Final Safety Evaluation Report for the Early Site Permit Application for the Clinch River Nuclear Site

U. S. Nuclear Regulatory Commission
Office of New Reactors
Washington, DC 20555-0001

June 2019

This final safety evaluation report[1] (FSER) documents the U.S. Nuclear Regulatory Commission (NRC) staff's safety review of the early site permit (ESP) application submitted by the Tennessee Valley Authority (TVA or the applicant), for the proposed Clinch River Nuclear (CRN) Site, in Roane County, Tennessee.

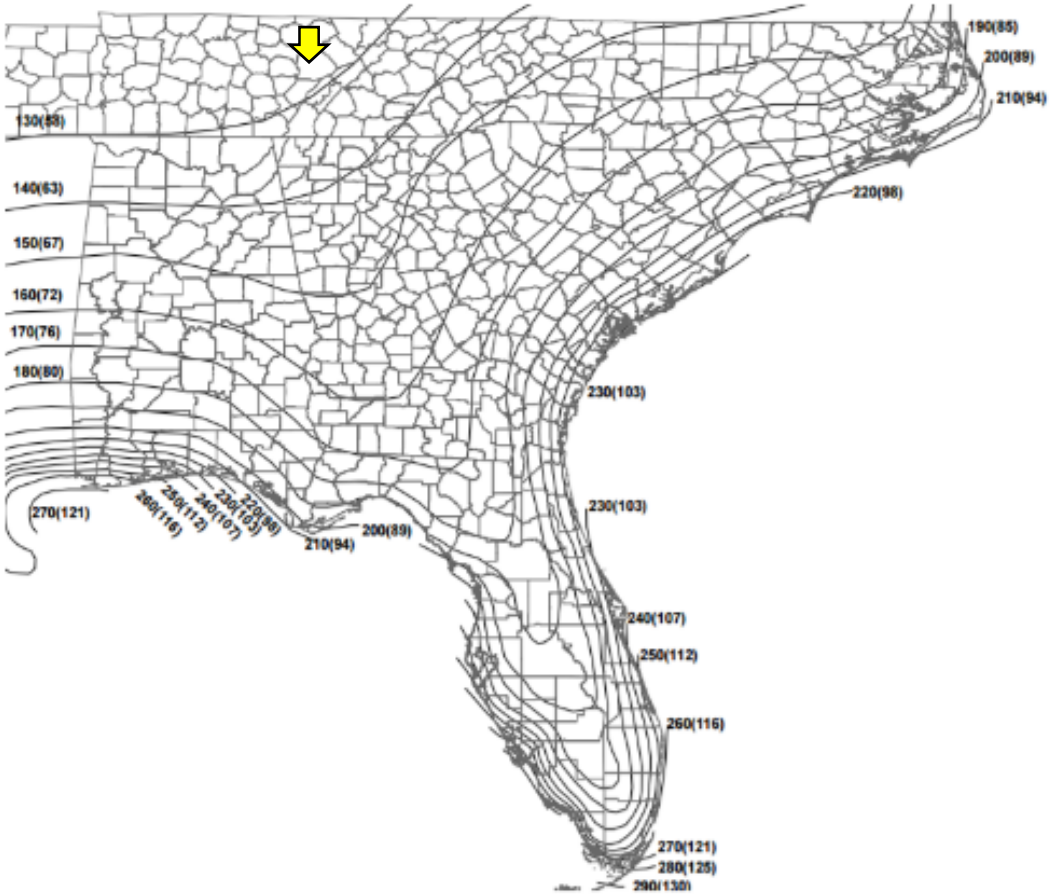
The applicant provided a site characteristic hurricane wind speed of 130 mph (3-second wind gust speed) in SSAR Table 2.0-1. Based on Figure 2.3-1, which is reproduced from RG 1.221

(NRC 2011-TN5931) and confirms applicant's site hurricane wind speed, the staff agrees with the applicant's conclusion and finds this information acceptable.

Figure 2.3-2 Effluent Release Zones with Analytical EABs

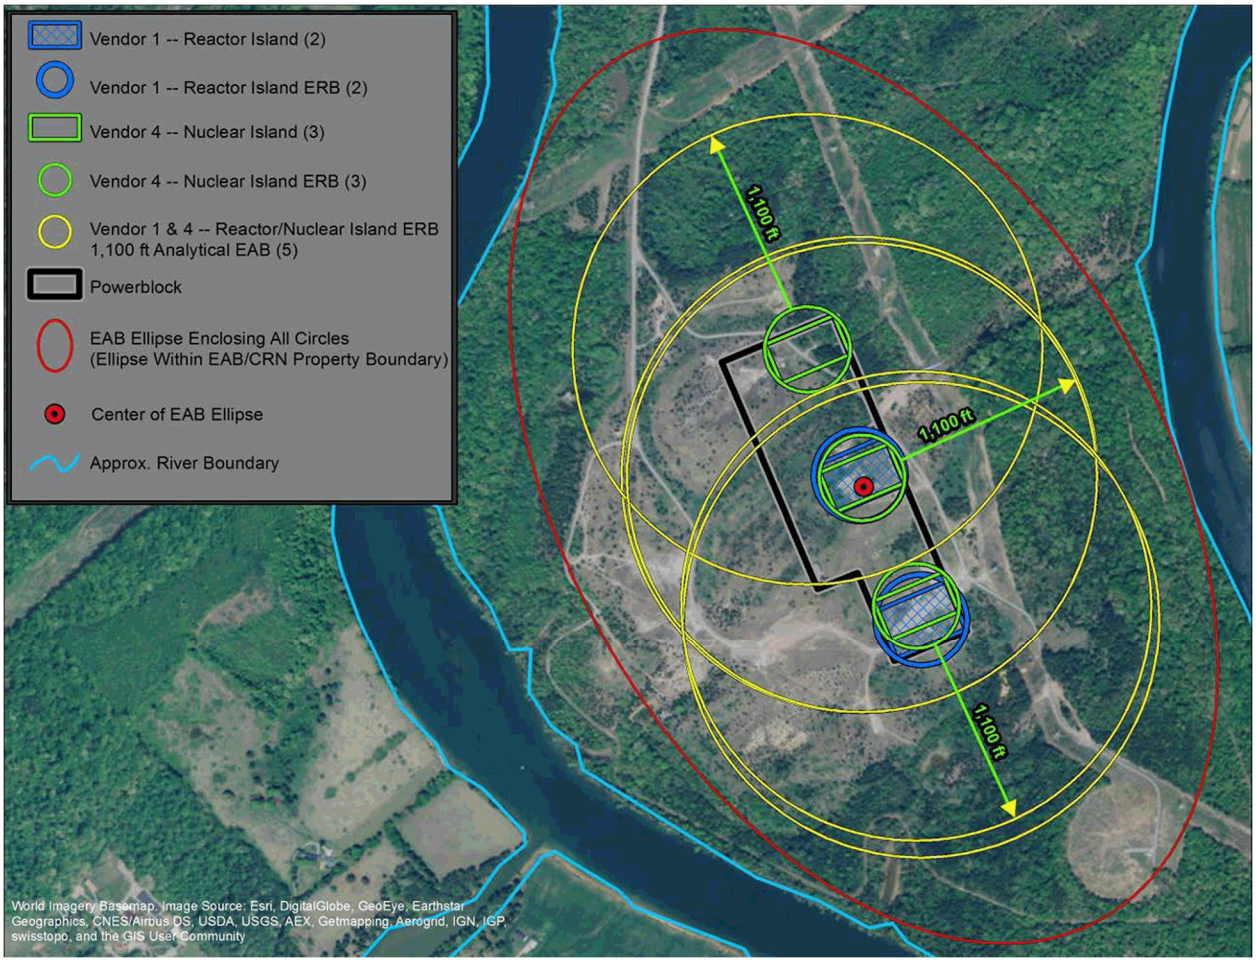
the EAB and LPZ in the 16 Wind Direction Sectors," and SSAR Figure 2.3.4-1 (reproduced below as Figure 2.3-2) (TVA 2017-TN5387). To account for the potential for multiple units on the site, nuclear islands are positioned at multiple locations within the power block area with associated ERBs and EABs, as shown in Figure 2.3-2 below. A circular analytical EAB is established 335 m (1,100 ft) from the ERB. All of the potential nuclear island sites are bounded by the ellipse shown below that encompasses all of the analytical EAB and is completely contained within the CRN Site. Because the distance from the outer edge of the power block to the EAB is less than the actual distance from the nuclear island to the EAB, and would result in higher (more conservative) χ/Q values, the staff considers the assumptions in the dispersion analysis to be reasonable.

Figure 2.4.1-5a Seasonal Operating Curve for Watts Bar Dam (reproduced from SSAR Revision 1, Figure 2.4.1-6, Sheet 1 of 11 [TVA 2017-TN5387]).

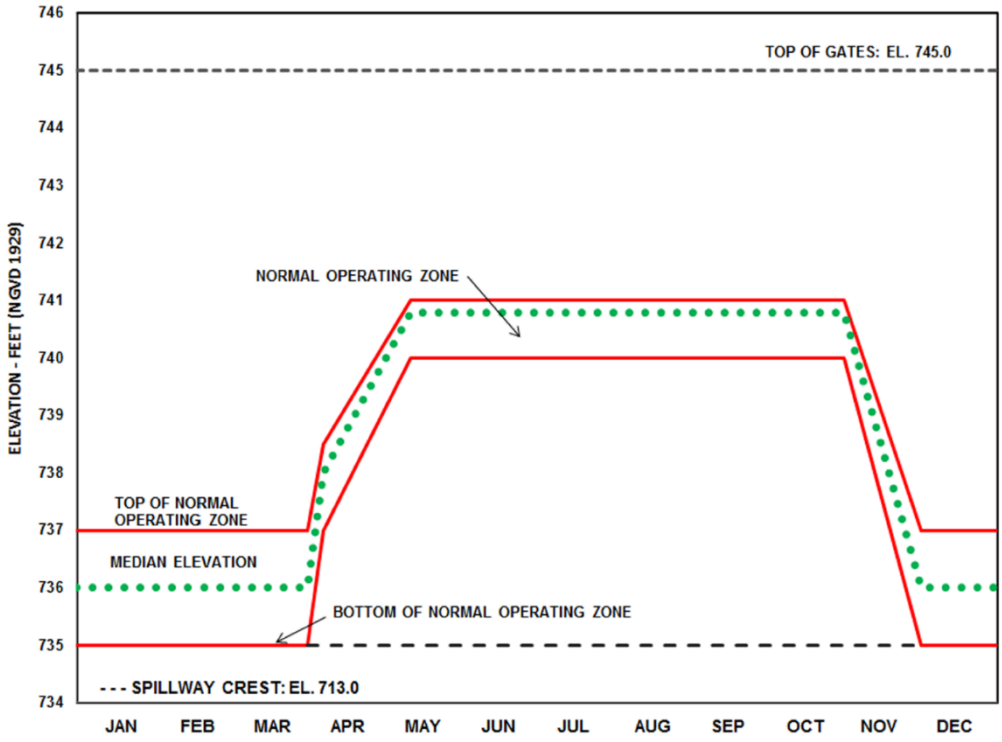
The staff compared the summer normal pool elevation of 741 ft NGVD29 and the winter normal pool elevation of 737 ft NGVD29 (Figure 2.4.1-5a) of the Watts Bar Reservoir to the applicant's proposed grade elevation of 821.4 ft NGVD29 (821.0 ft NAVD88), as indicated in Section 2.4.0 of the SSAR (TVA 2017-TN5387). The staff notes that the elevation difference between the CRN Site site grade and the normal WSE of the reservoir near the site is approximately 80 ft.

Figure 2.4.12-4 Hydrograph of OW-417 Well Pair (top) and, (bottom) Hydrologic Cross Section through the Clinch River, OW-417, OW-418, OW-202, and OW-423 from Left to Right (reproduced from Figures 2.4.12-29 and 2.4.12-32 [TVA 2017-TN5387]).

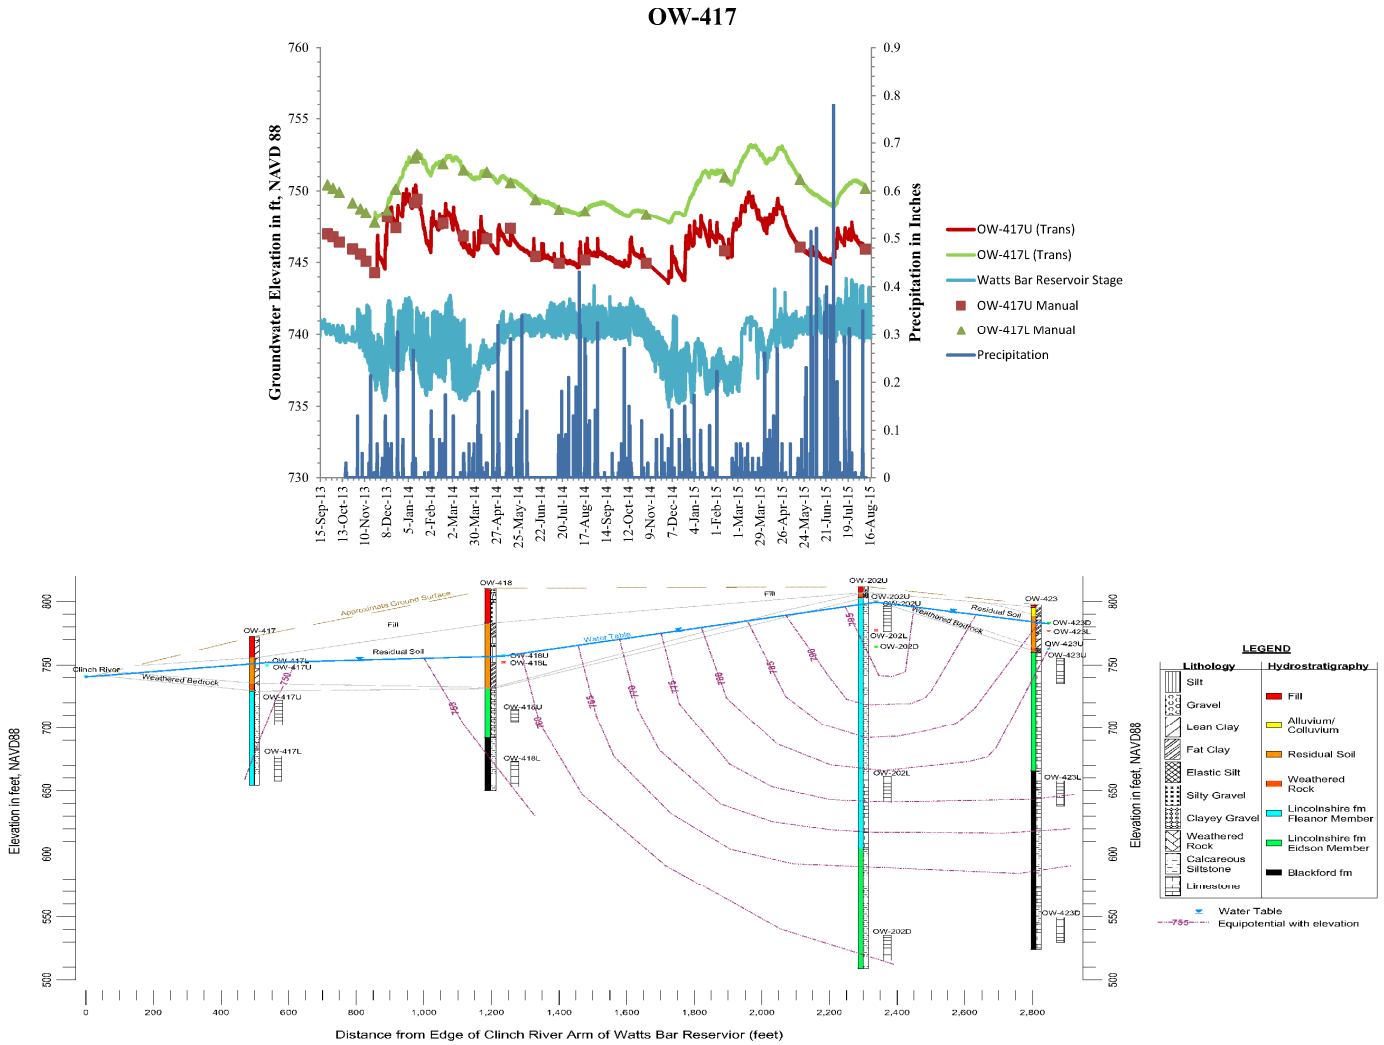
During the monitoring period (September 2013 to August 2015), groundwater gradients from OW-417 U/L were consistently upward at this well pair, which is adjacent to the Clinch River. The upward groundwater gradient (Figure 2.4.12-4) exhibited no observable correlation with the Clinch River stage over the monitoring period, indicating steady-state conditions. The consistent downward gradients in the upland areas of the site suggest precipitation recharge areas (e.g., at OW-202U/L/D well cluster) and upward hydraulic gradients near the Clinch River (e.g., at OW-417U/L); this indicates that the Clinch River acts as a discharge point for the shallow groundwater system flow from the CRN Site.

Figure 2.4.12-5 Location of Wells and Hydrologic Transects Along the Clinch River and, Cross Sections Along Transects A, B and C (after Bechtel Jacobs Company [2011-TN6169], Figures 7, 8, 9, and 10).

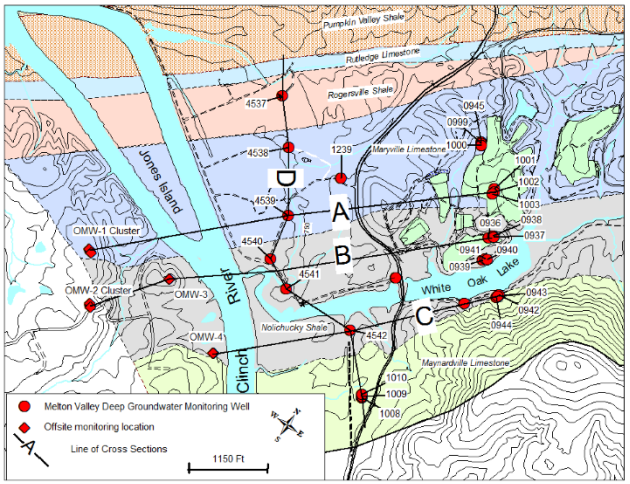
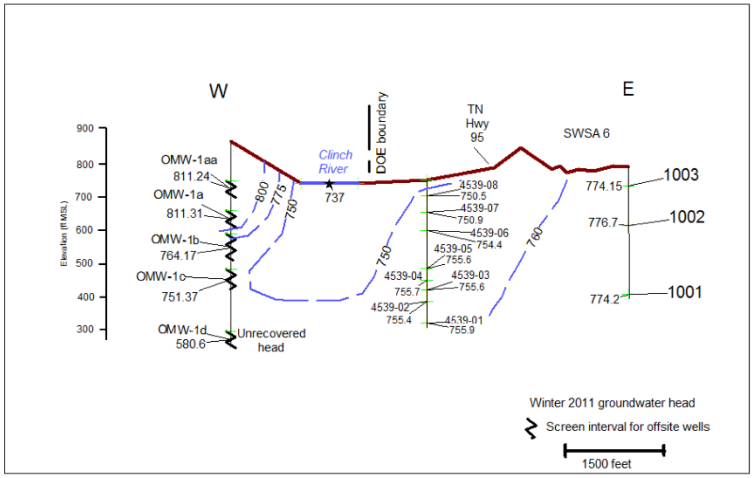
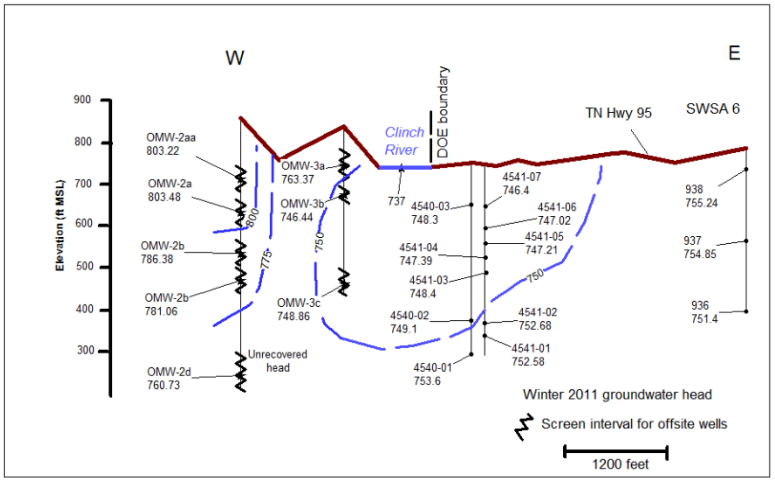
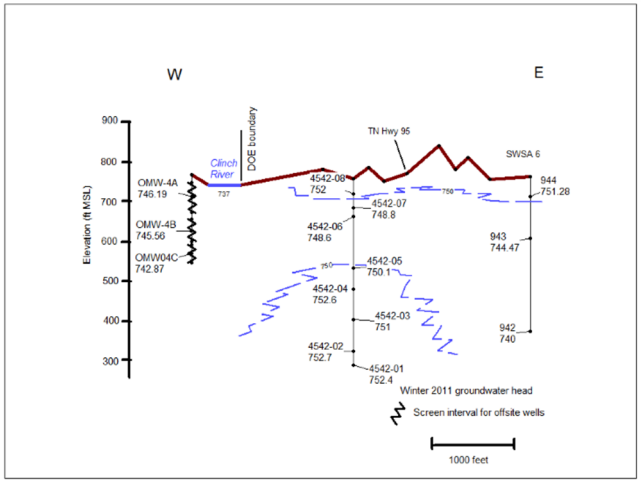
This trend is consistent with gradients near the Clinch River, as observed in studies conducted at the nearby ORR (Bechtel Jacobs Company 2011-TN6169; Dorsch and Katsube 1999-TN6036), indicating upward groundwater gradients toward the Clinch River at depth (Figure 2.4.12-5).

The applicant described precipitation as the primary source of surficial recharge to the aquifer system with minor contributions from the Clinch River during high stages. As described above, the applicant cited a study by the DOE (Bechtel Jacobs Company 2011-TN6169) indicating discharge to the Clinch River from the surrounding shallow groundwater flow system in the vicinity of the ORR (Figure 2.4.12-5) consistent with patterns on the CRN Site.

Figure 2.5.2-7 Comparison of the Applicant's Base Rock Hazard Curves with the Staff's Confirmatory Hazard Curves for the CRN Site

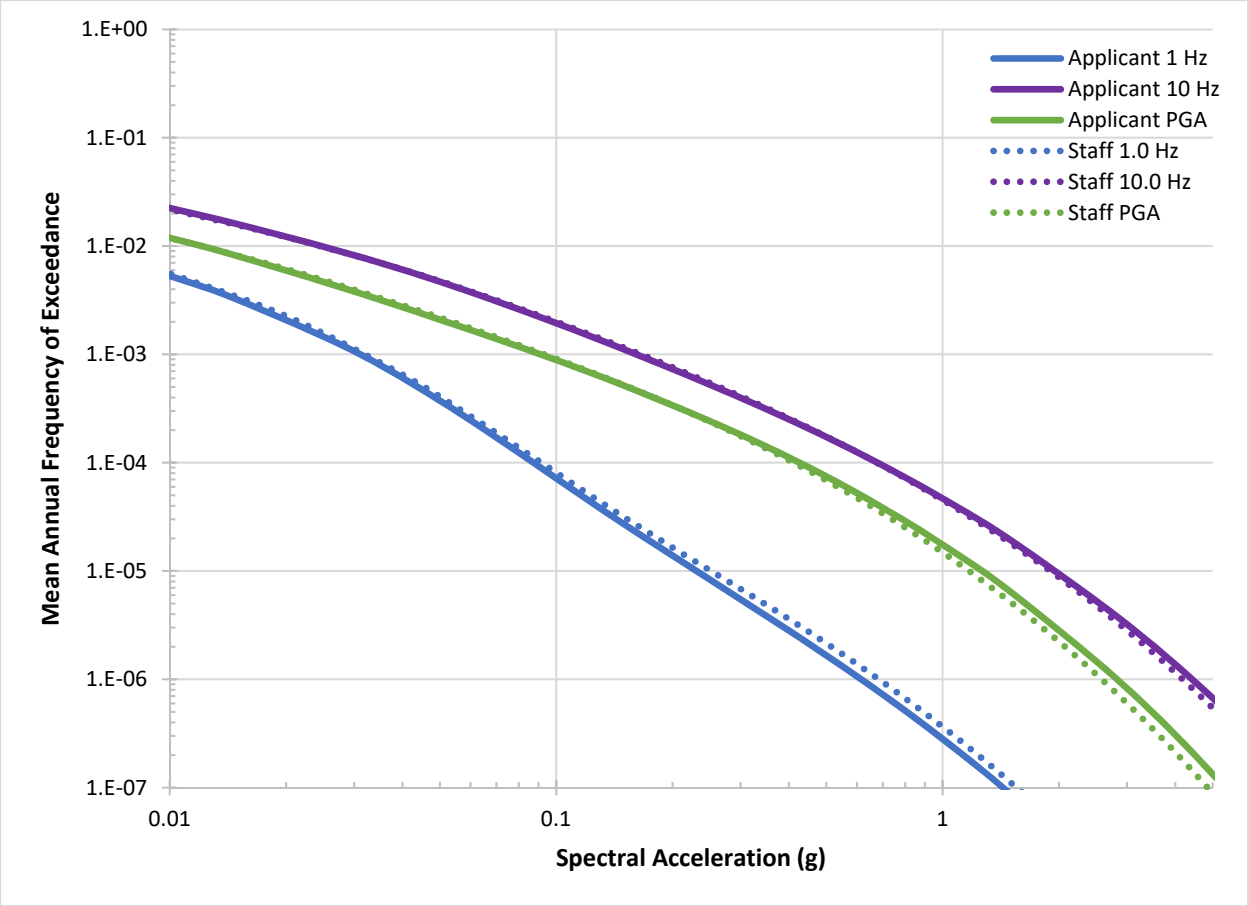
To assess the applicant's update of the recurrence parameters for the CEUS-SSC models, the staff reviewed the applicant's methodology, updated parameters, and performed its own independent confirmatory analysis, discussed in FSER Section 2.5.2.3.4.2. In considering the applicant's updated recurrence parameters, the staff reviewed the updated catalog and the applicant's maps of updated recurrence parameters (e.g., SSAR Figure 2.5.2-27 [TVA 2016-TN5018]). The updates to the recurrence parameters as a result of catalog updates are minimal and have a negligible impact on the PSHA results, as shown in Figure 2.5.2-7. Based on the staff's review and confirmatory analysis, the staff has determined that the applicant's updates are acceptable.

Figure 2.5.2-8 Comparison of the Applicant's (blue) and the Staff's Confirmatory GMRS (red) for the CRN Site. The generic hard rock (V_S = 2.8 km/s [9,200 fps]) GMRS (black dotted) is shown for comparison.

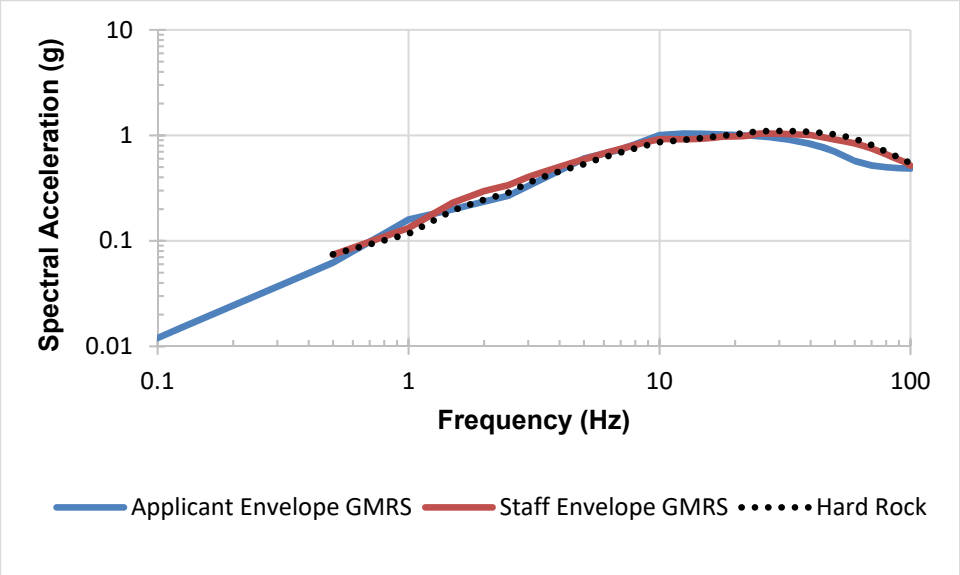
horizontal GMRS (for each spectral frequency) is obtained by scaling the 10^{-4} soil UHRS by the design factor specified in RG 1.208 (NRC 2007-TN5858). A comparison of the applicant's and the staff's confirmatory horizontal GMRS is shown in Figure 2.5.2-8.
